# CITY OF PORTLAND

Job ID: 2011-10-2509-ALTR

has permission for Single Family Interior Renovations (add balcony over existing porch/ Change of Use).

**From:** Tammy Munson  
**To:** support staff  
**Date:** 10/20/2011 12:11 PM  
**Subject:** Fwd: Fw: 288 E. Prom  
**Attachments:** 11114 Ashby Revised.pdf

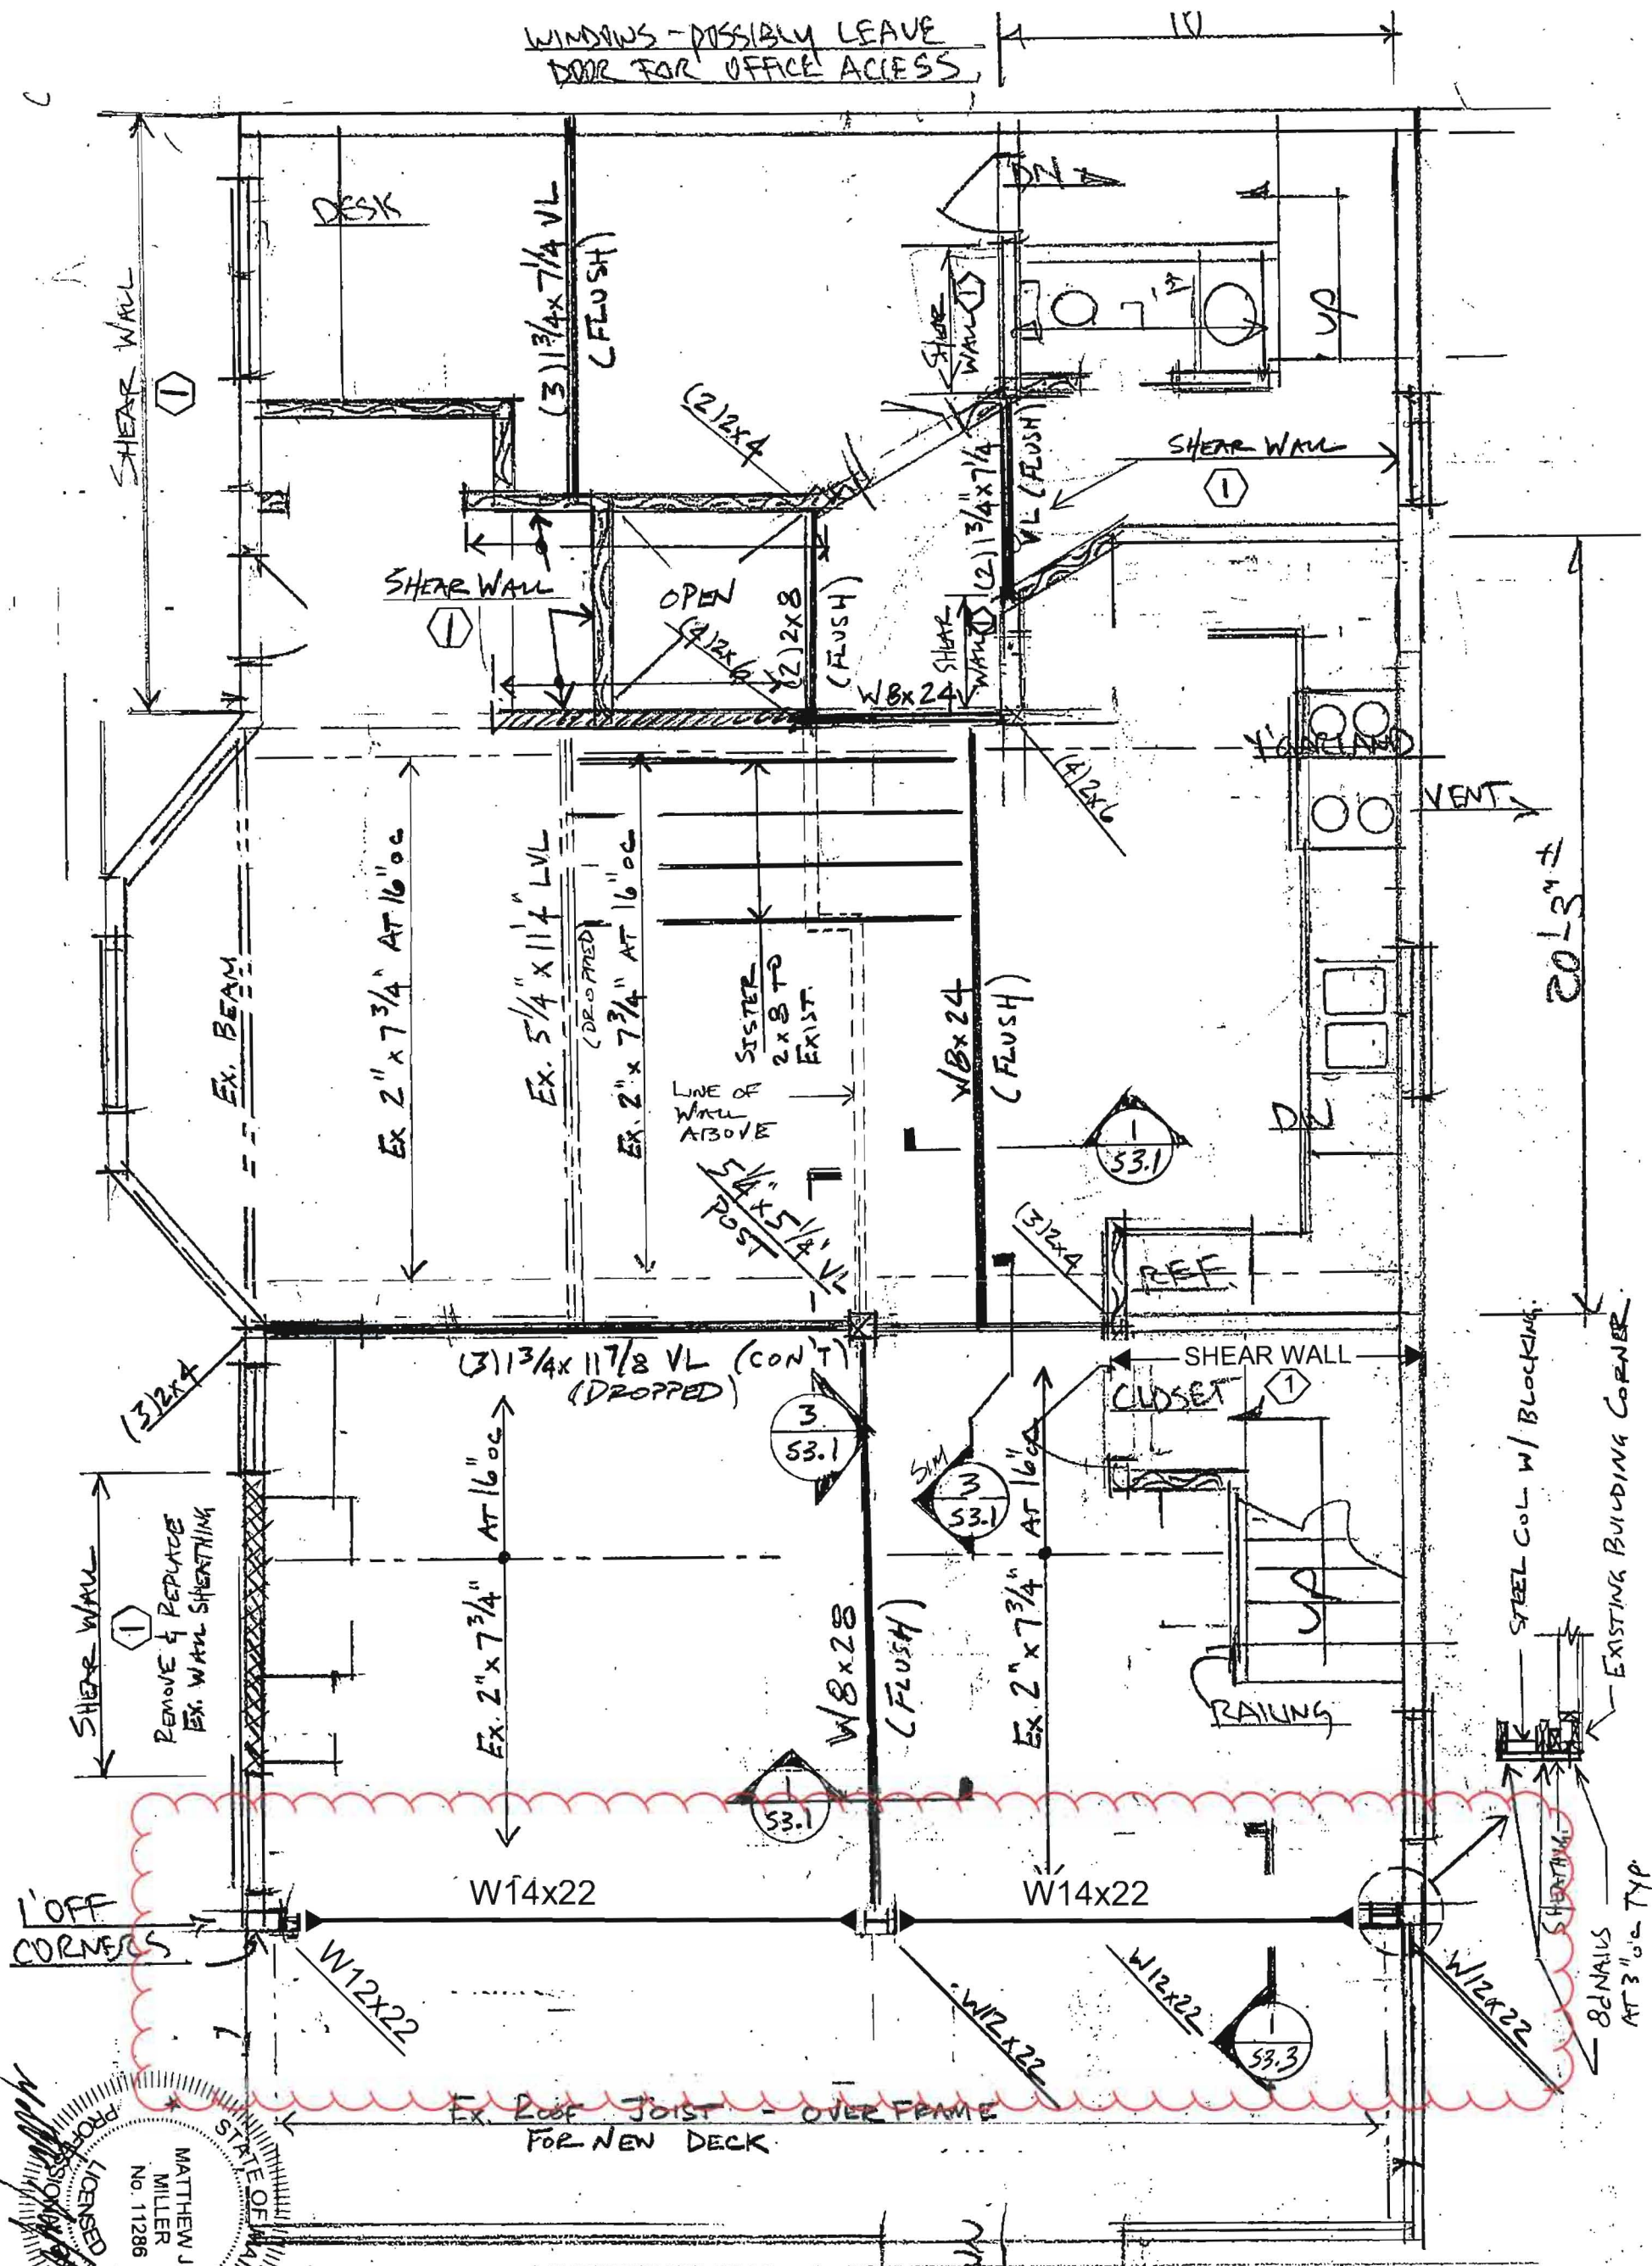
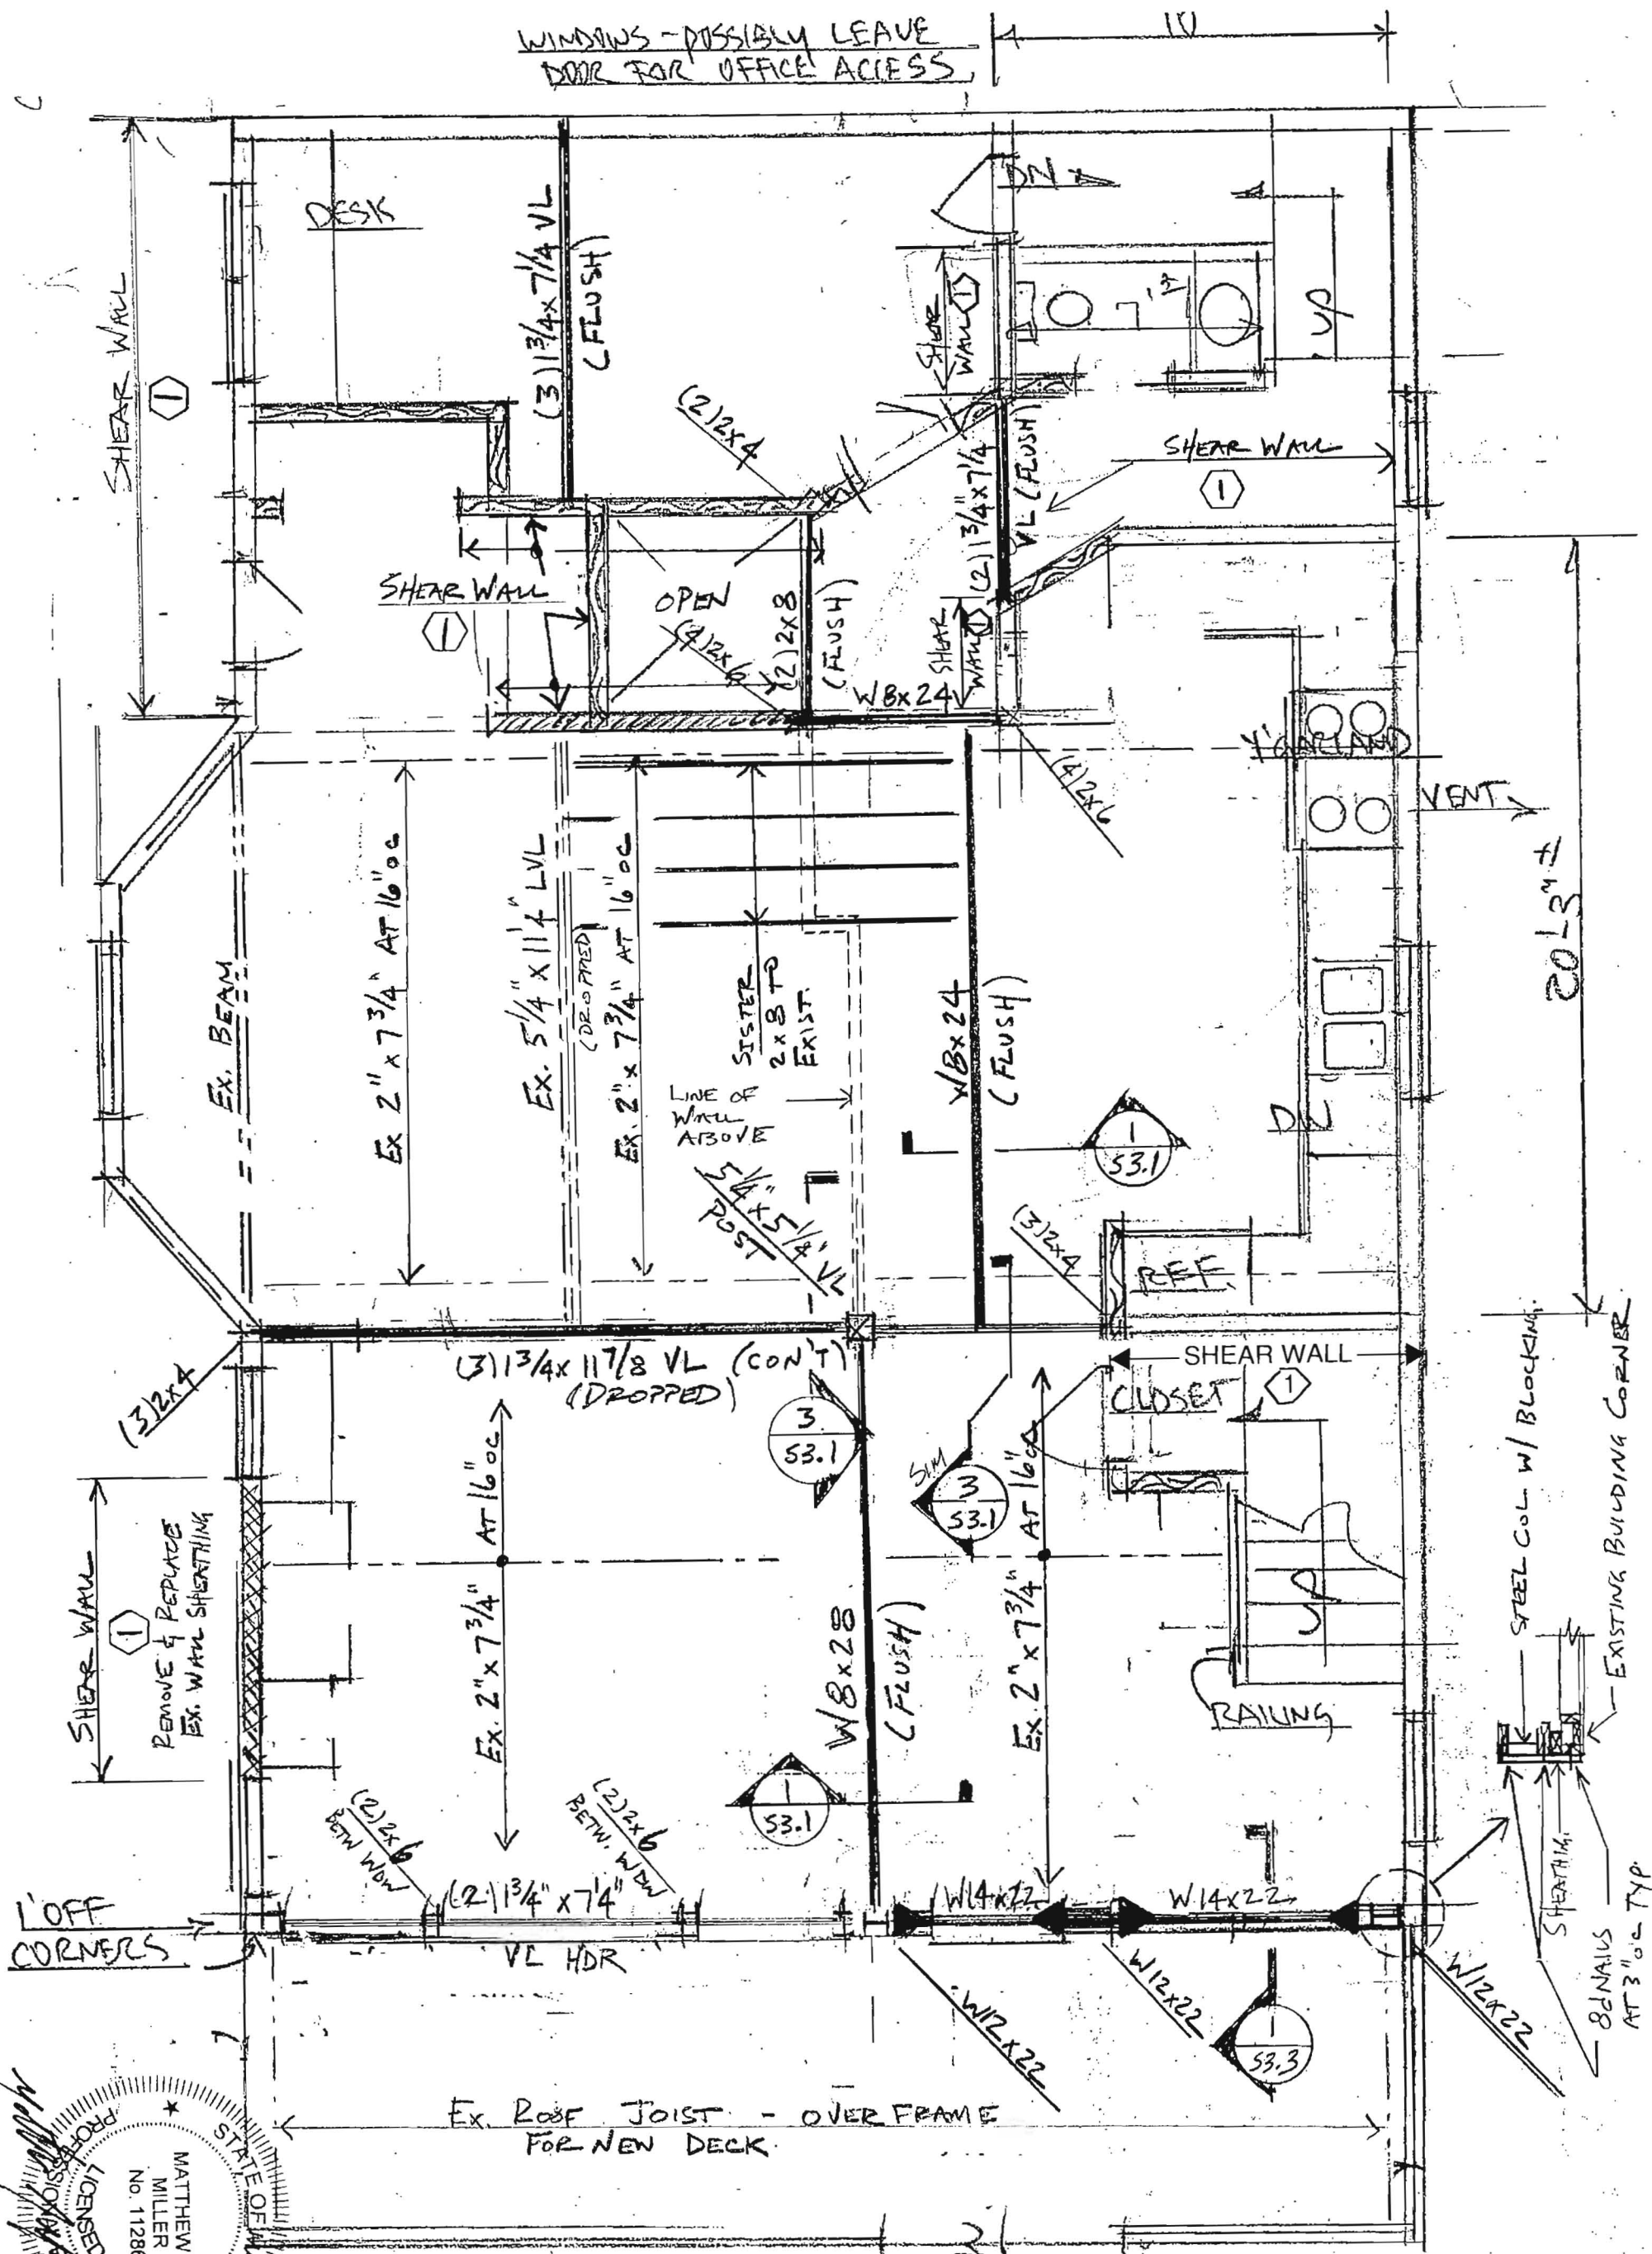
Please add this to the building permit request for 288 Eastern Promenade. The structural engineer decided to span the entire front wall header with a steel beam instead of only half of the wall. Please let me know if there is anything more needed in issuing a permit for this renovation. Thank you very much.

I received your voicemail from a bit ago. I had previously send the drawing with the change highlighted. It is attached to this message as well, as is a copy of my original message. There should not be very much cost differential with the modified moment frame dimensions.

I was thinking more about the project this weekend, and there was something about the moment frame I proposed along the front wall that was bothering me. As I currently have it detailed the base plates for the steel columns are sitting on the wood plate, which in turn is supported by the 6X8 "rim" joist at the first floor. Based on the age of construction, I doubt there is much of a connection between the rim and the CMU wall. I would need a decent connection at this location to resist the potential upward load potentially on this connection. Also, based on the foundation configuration, there is no easy way to get this uplift load from the steel columns to the concrete foundation wall. For these reasons I would like to make the attached adjustment to this frame, which basically extends the frame across the width of the house. By spreading out the columns, there is significantly less uplift load on the columns.
